Technical Service Information

THM 440-T4 MODULATOR VALVE "BUZZ" (CUP PLUG)

Figure 1

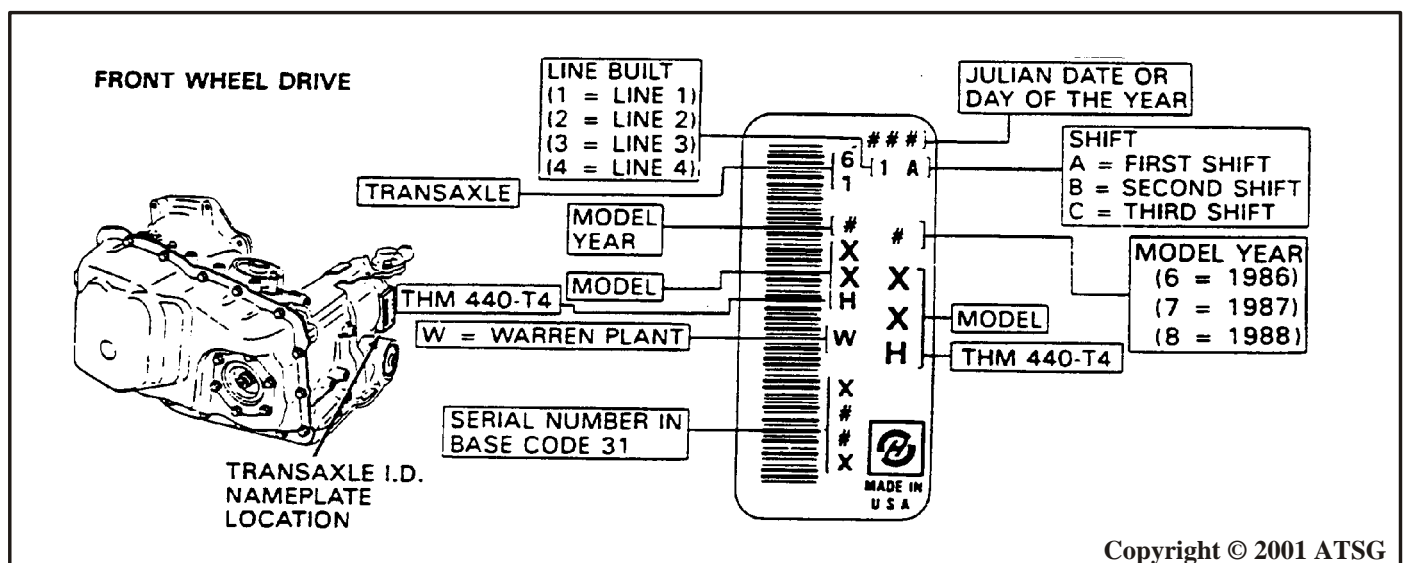
Bulletin Covers: (Figure 1)

Modulator valve buzz noise can be caused by a missing orificed cup plug in the modulator circuit of the channel plate for transaxles built prior to February 1, 1987 (Julian Date 032).

Figure 2

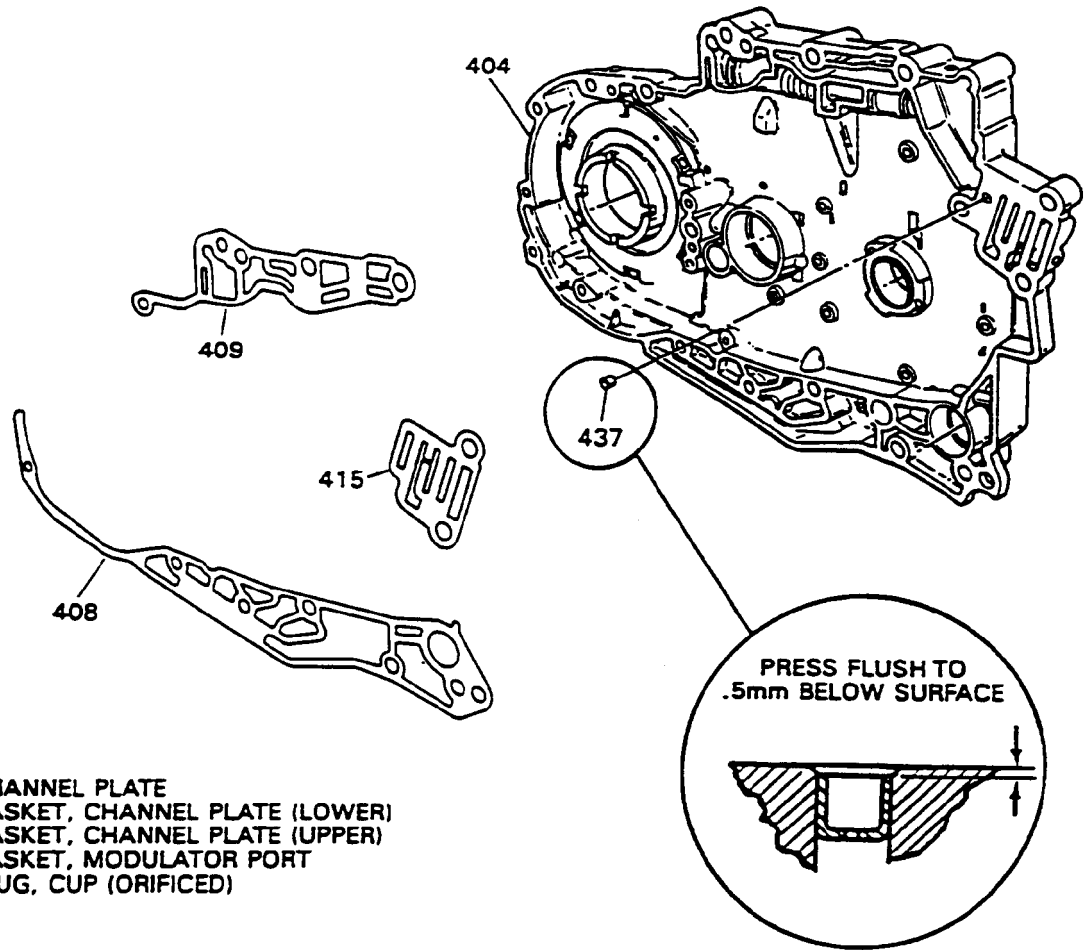
Service Action: (Figure 2)

Remove the transaxle from the vehicle and remove the channel plate (404) from the transaxle. Install the orificed cup plug (437) from the service package listed in "Service Parts Information". The cup plug is properly installed at 0.0 - 0.5 mm (.020") below the channel plate machined surface and must be staked securely.
